WORKSHOP AGENDA

Planning Commission
February 10, 2026 @ 5:30 PM
For the February 24, 2026 Regular Meeting @ 6:00 PM

Planning Commission Report
Meeting: February 10, 2026

DRAWING NUMBER
C7.0

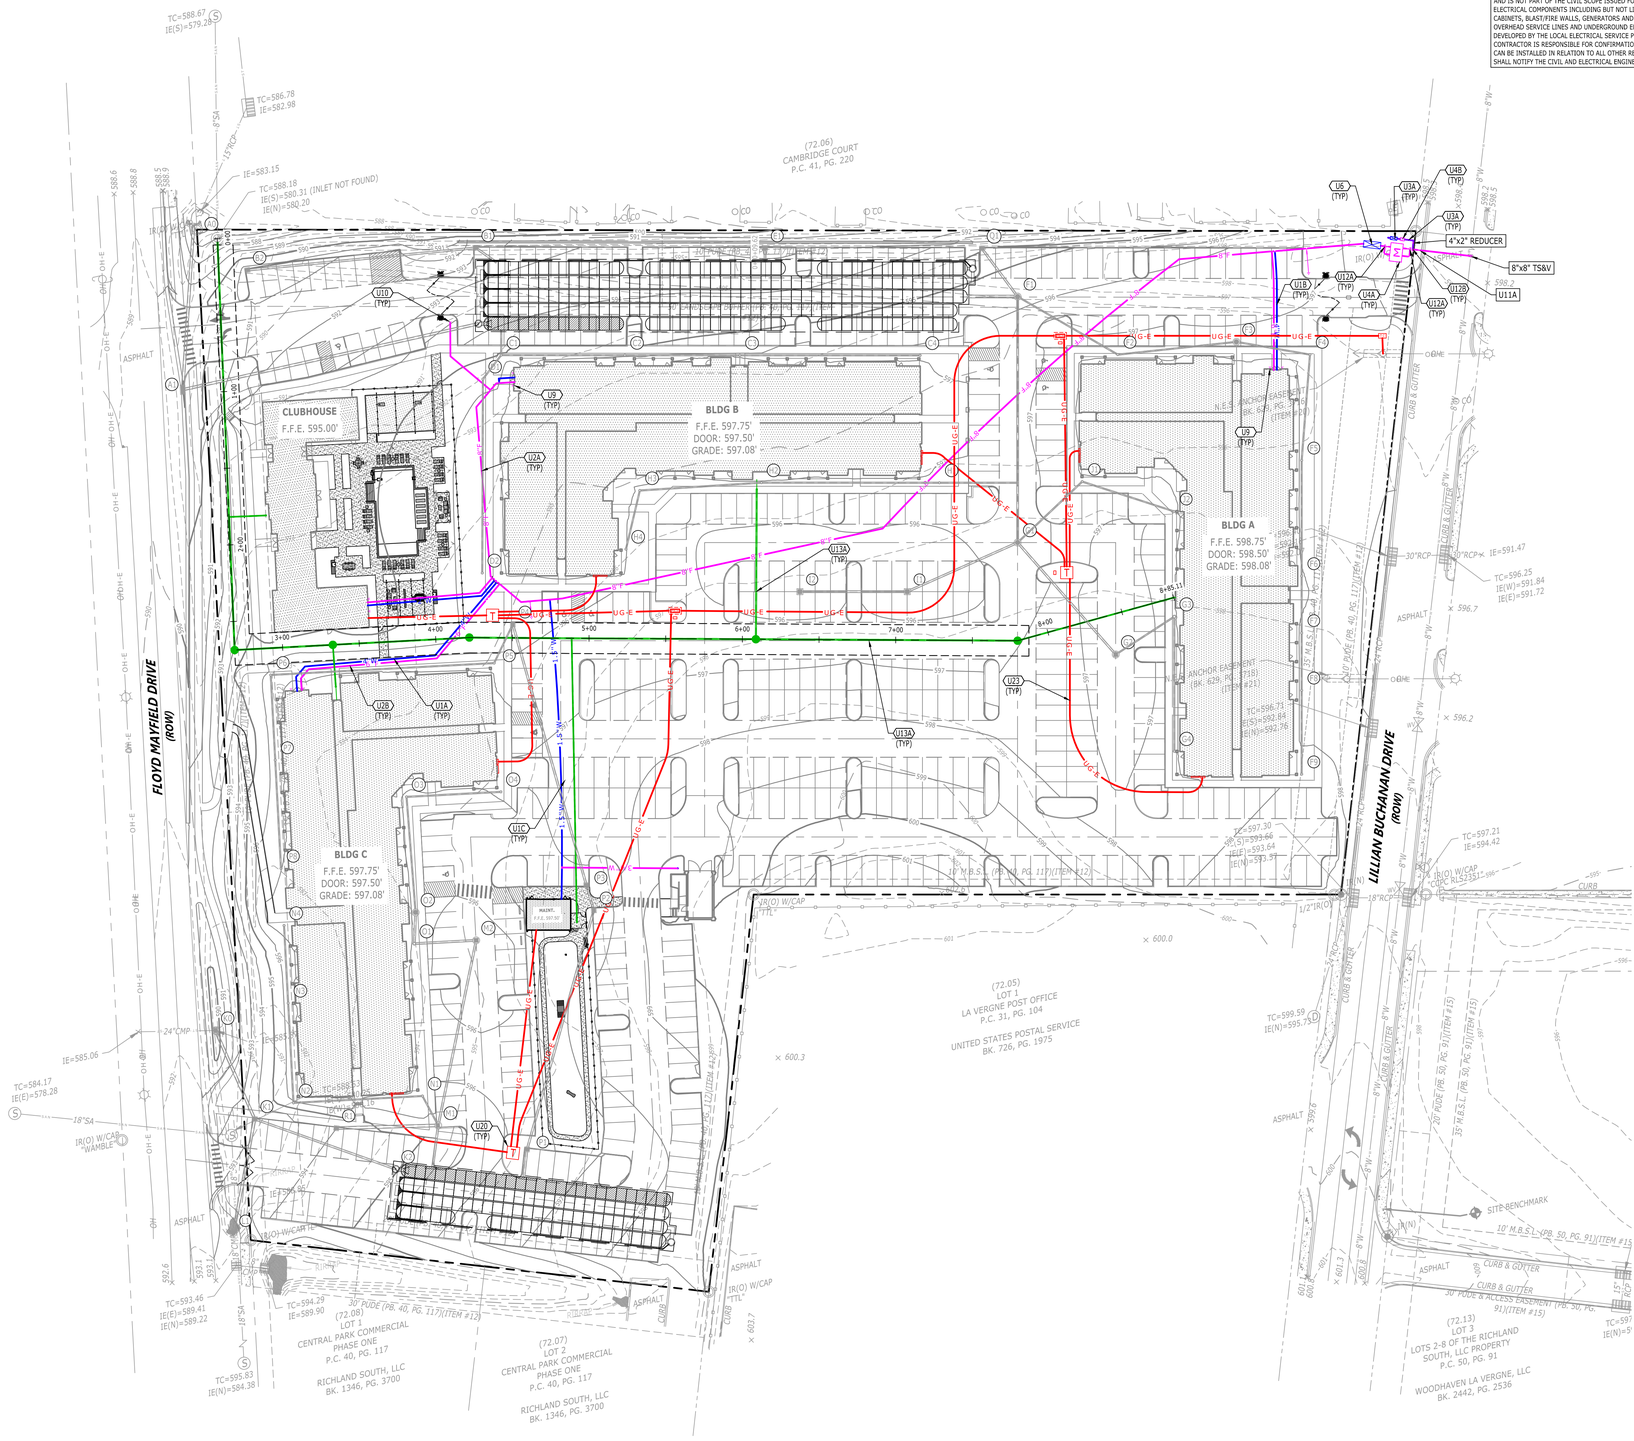
1. Sht C7.0 – Water and sewer lines shall have a defined alignment. Example for sewer: Provide coordinates at each manhole; or bearings of each line and pipe stationing, including a coordinate at one of the manholes (angle points) for survey control. Utilities are installed first and need to be staked properly per the plans. Currently there is no control for the utility alignments.

2. Sht C7.0 – Add symbols to legend for FDC, water valve, thrust block, sewer manhole, and other if needed.
3. Sht C7.0 – Show a fire hydrant symbol of legible size in plan view, label each occurrence.

4. Sht C7.0 – Show FDC symbols of legible size in plan view, label each occurrence.
5. Sht C7.0 – FDCs shall be a single 5” Stortz.
6. Sht C7.0 – FDCs shall be at least 50 feet from the building.

7. Sht C7.0 – FDCs shall be no greater than 100 feet from a fire hydrant.
8. Sht C7.0 – FDC shall supply only the sprinkler piping downstream of all control valves. A DCDA shall separate the FDC supply from the domestic portion of the waterline supply in the riser room of the building. Riser room detail may be provided with the building architectural drawings. Other option is dual water plumbing (separate domestic and firelines throughout the site), then a single FDC may be allowed on the fireline piping with an open/closed status indicating, control valve on each building’s sprinkler piping.

9. Sht C7.0 – Revised waterline alignments onsite. Per TDEC Community Public Water Systems Design Criteria, waterlines shall be designed with 10-foot horizontal clearance from sewer and storm drain pipes, where possible.

10. Sht C7.0 – Submit estimated irrigation flowrate for the City to size and determine the type of irrigation meter.
11. Sht C7.0 – For Note U4B, add the words: “per City Std Dtl W-040” at the end of the note. City recently developed a standard detail for 2” irrigation meters, that has yet to be published. Scott Tatalovich, Utility Engineer, can email you a pdf of the new detail, or you can reach him at statalovich@lavergnetn.gov, to request information.

13. Sht C7.0 – Question: Do you really want to use a 2”DW line to the compactor location off a long 1-1/2” waterline serving the Maintenance/Pet Wash?
14. Sht C7.0 – Regarding Developer comment response to previous Utility Comment #2: A public cleanout shall be located per City Standard Dtls 1.0 and 2.0 within the public utility easement. It may be a double sweep cleanout. It is required for City to perform maintenance on its portion of the public sewer service.

15. Sht C7.0 – Manhole A1 is not labeled.
16. Sht C7.0 – Informational Comment: Electrical conduits will also be required for both heated above ground backflow preventer enclosures.

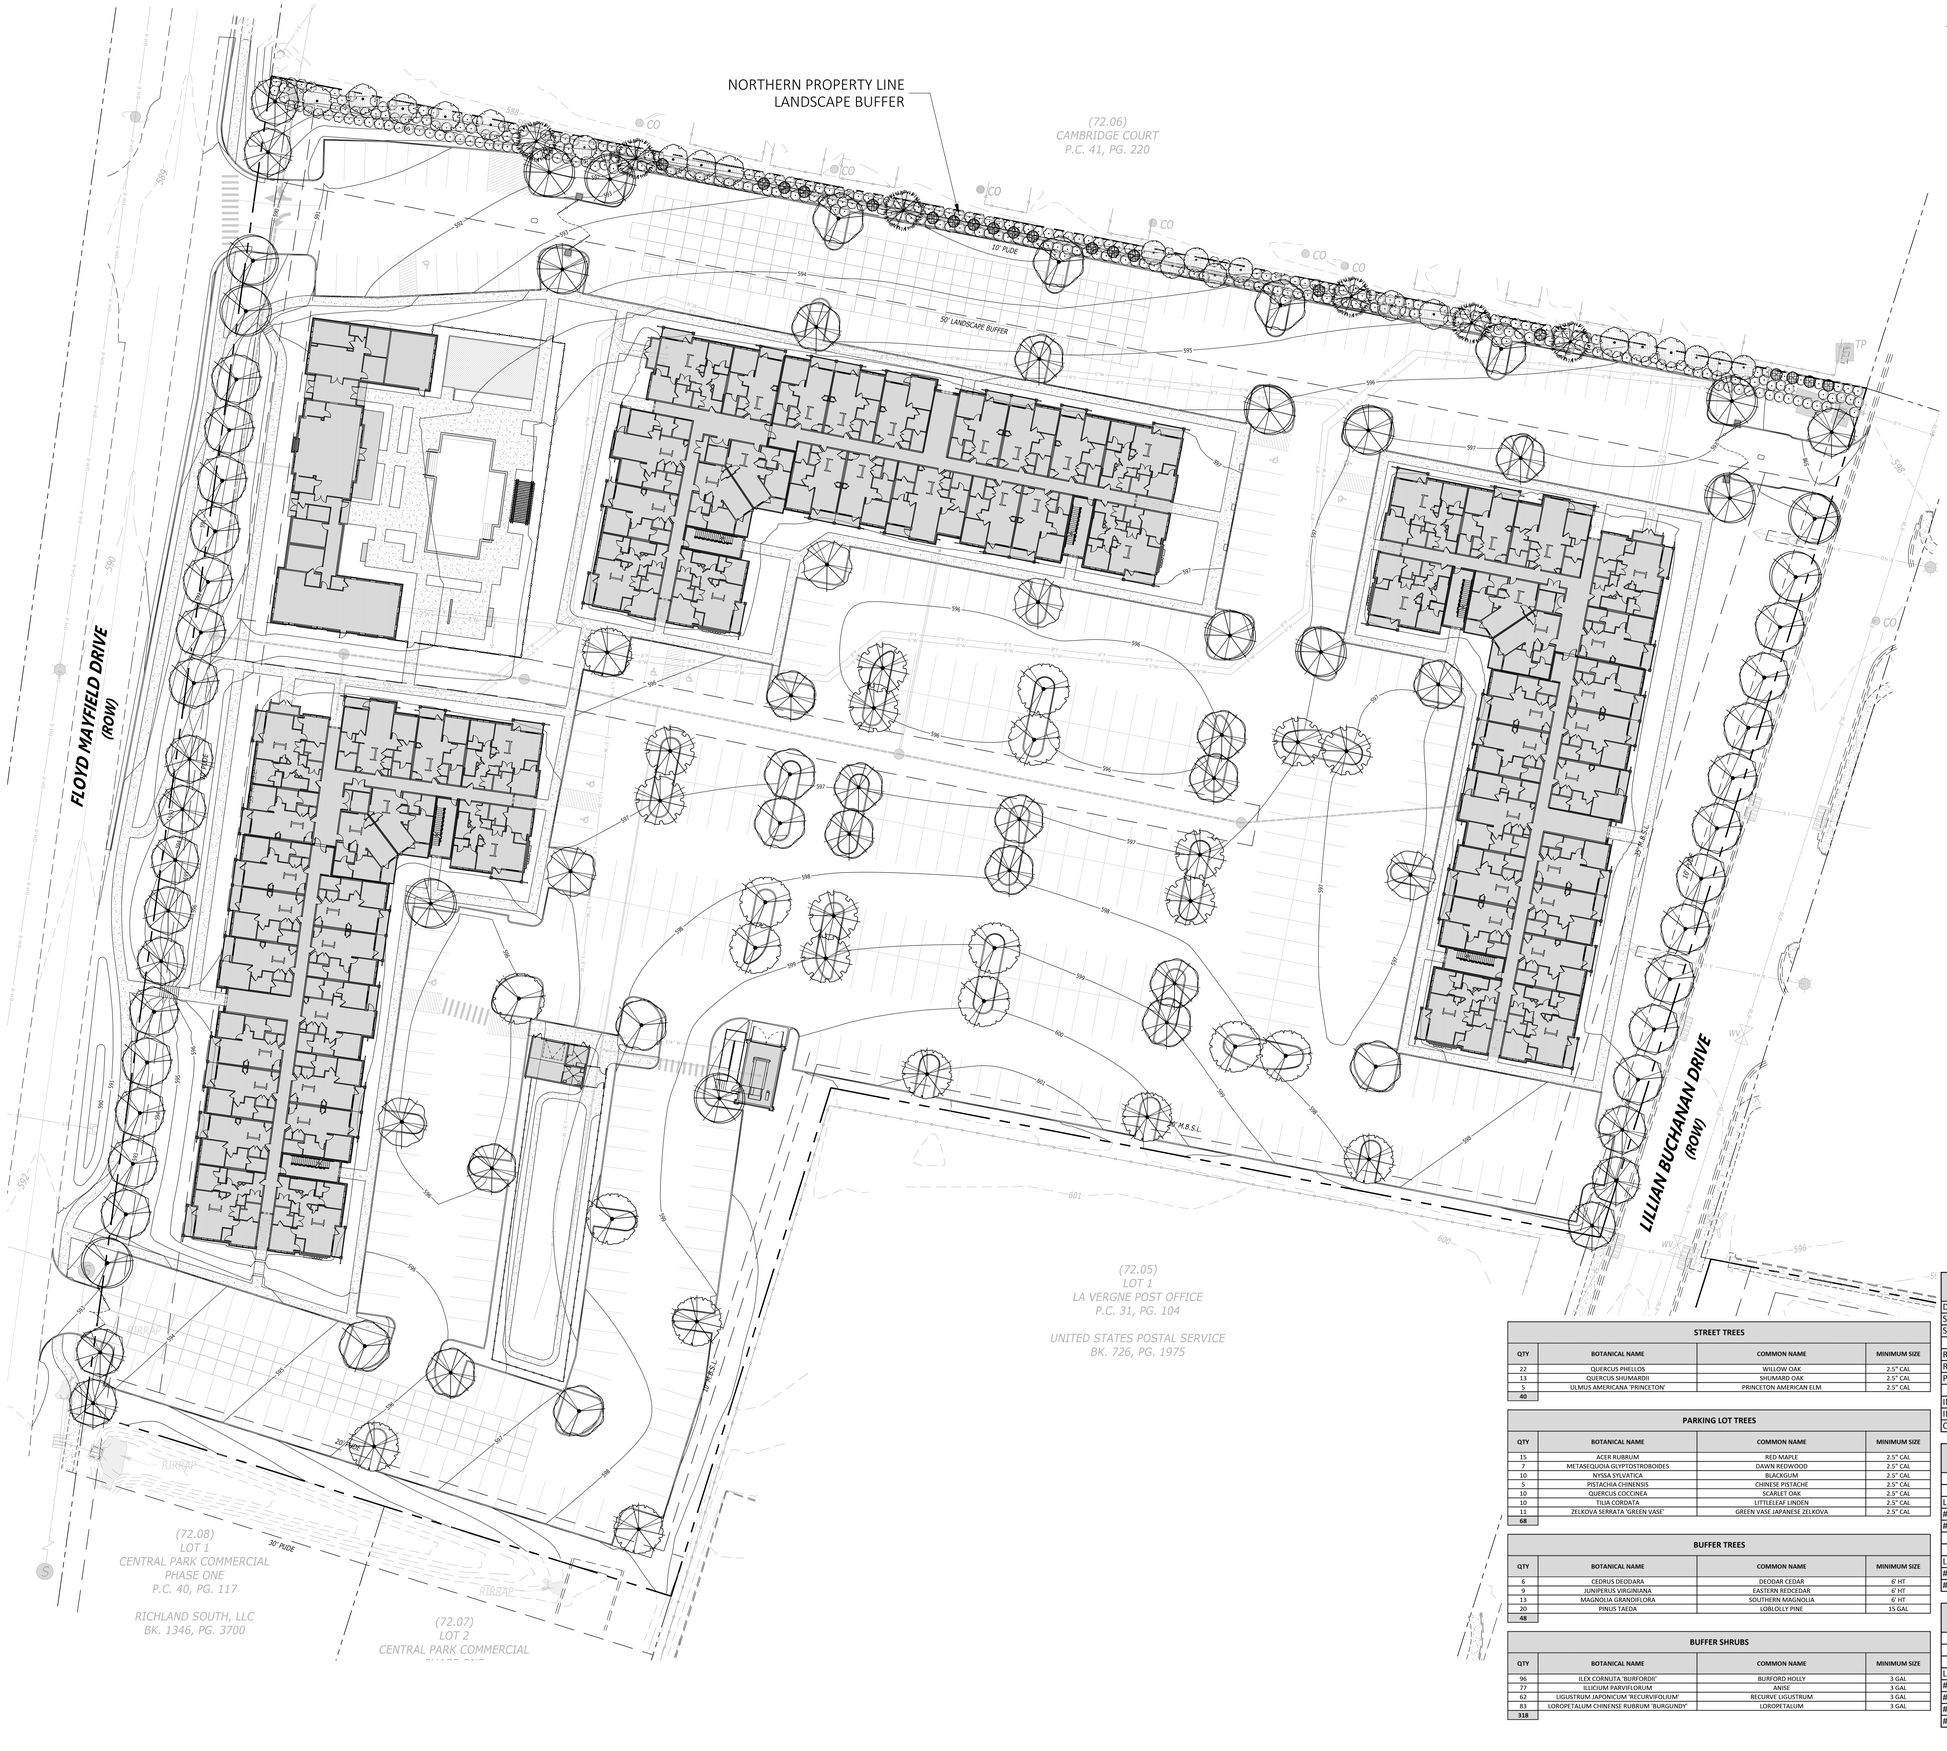
29. Sht L1.0 – Two trees at northwest entrance are shown within 10 feet of sewer line, suggest relocate trees (or remove if planning department staff allow this). However, sewer is not presently shown in the center of the utility easement shown, so it’s difficult for City to determine what should be done move sewer or relocate trees. In any case keep trees away from sewer.
